UNITED STATES PATENT AND TRADEMARK OFFICE

APPLICATION NO.	FILING DATE	FIRST NAMED INVENTOR	ATTORNEY DOCKET NO.	CONFIRMATION NO.
10/736,402	12/15/2003	Joseph R. Rostron	4S01.1-060	6199

Office Action Summary	Application No. 10/736,402	Applicant(s) ROSTRON ET AL.	
	Examiner Scott Bauer	Art Unit 2836

DETAILED ACTION

FIG. 1

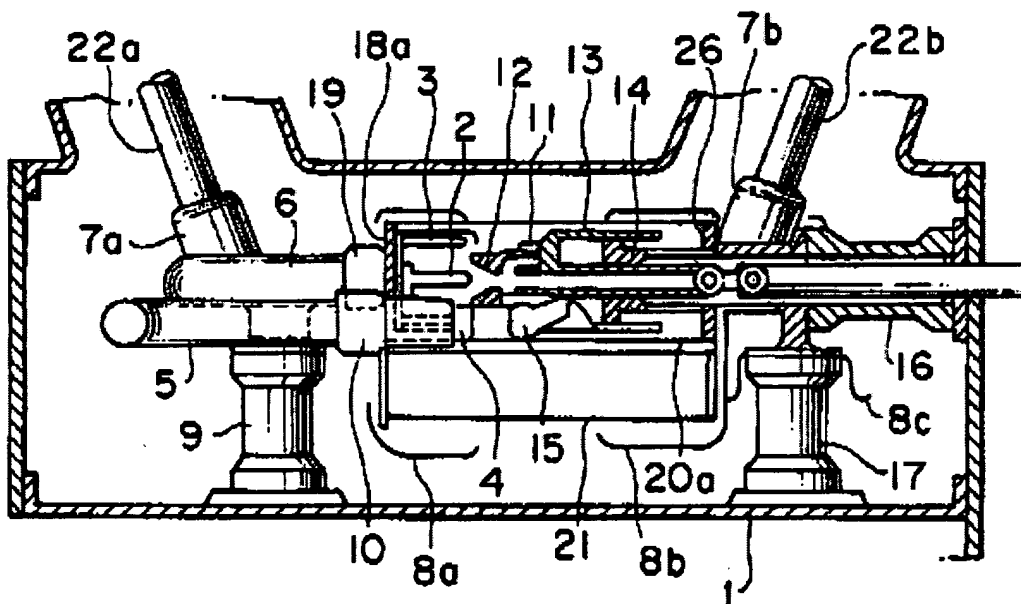
5. With regard to Claim 1, Thuries et al., in Figures 1 & 2, discloses an electric power switch, comprising: an impedance (8); a power contactor comprising a linearly moving contactor having a fixed contact (21) and a moving contact (34), and operable for closing an electric power circuit on a closing stroke and opening the electric circuit on an opening stroke; an impedance contactor operable for entering the impedance into the circuit on the closing stroke (column 4 lines 30-35) and removing the impedance from the circuit on the opening stroke (column 5 lines 12-29); the impedance contactor comprising a linear moving butt contactor (51) having a retracting contact (20) positioned adjacent to the fixed contact (21) of the power contactor and a traveling contact (62) that moves with the moving contact of the power contactor (34); a timing device (40) operable for causing the impedance contactor to close before the power contactor on the closing stroke, and to cause the impedance contactor to open before the power contactor on the opening stroke, and a container (1) filled with dielectric gas, (column 2 lines 45-48) housing the power contactor and the impedance contactor (column 1 lines 45-65).

6. With regard to Claim 2, Thuries et al., in Figures 1 & 2, discloses the electric power switch of Claim 1, and further discloses that the container (1) comprises an insulator (column 2 lines 45-48) extending between first (3') and second (30) ends a sufficient distance to prevent arcing from occurring between a first electric power terminal located at the first end and a second electric power terminal located at the second end when a rated voltage for the switch is applied across the power terminals.

7. With regard to Claim 4, Thuries et al., in Figure 1, discloses the electric power switch of Claim 2, wherein the impedance (8) is housed within a conductive cap (7) (column 2 lines 60 & 61). The conductive cap comprising the first electric power terminal located at the first end of the insulator (1). In paragraph 0047, the applicant discloses that the insulator (8) also includes an upper insulator section (8) that extends from the line terminal (30) to a capacitor terminal (3'), which is electrically connected to the conductive end cap (through flange 6).

10. With regard to Claim 8, Thuries et al., in Figures 1 & 2, discloses the electric power switch of Claim 1, wherein: the retracting contact (20) of the impedance contactor comprises a conductive ring positioned around the fixed contact (21) of the power contactor; and the traveling contact (62) of the impedance contactor comprises a conductive ring positioned around the moving contact of the power contactor (34).
